PLAN: BALANCED SNOW LOADS

BUILDING 6

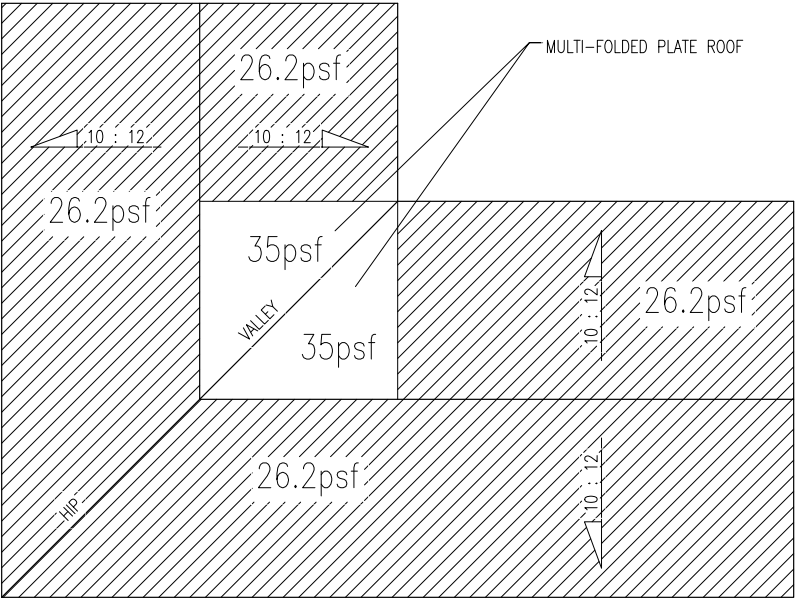
ORTHOGONAL DIRECTIONS ONLY???
IF NOT, UNBALANCED SL COULD BE EQUAL
GROUND SL = 50PSF

PLAN: UNBALANCED/ DRIFTING SNOW LOADS

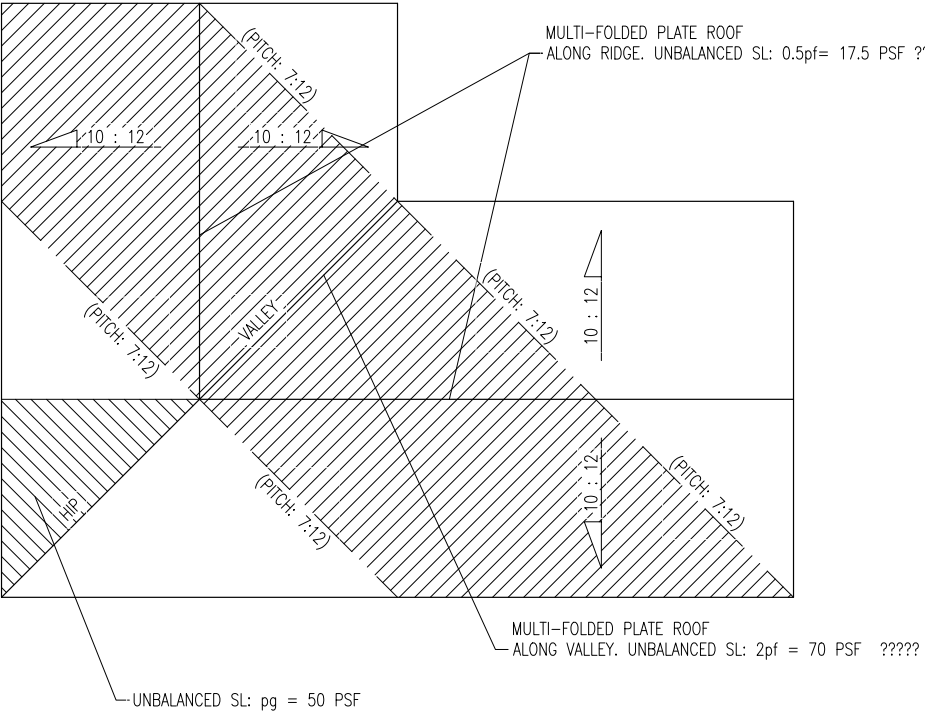
IF RAFTER PITCH < (7:12), UNBALANCED
SL PER O'ROURKE'S GUIDE
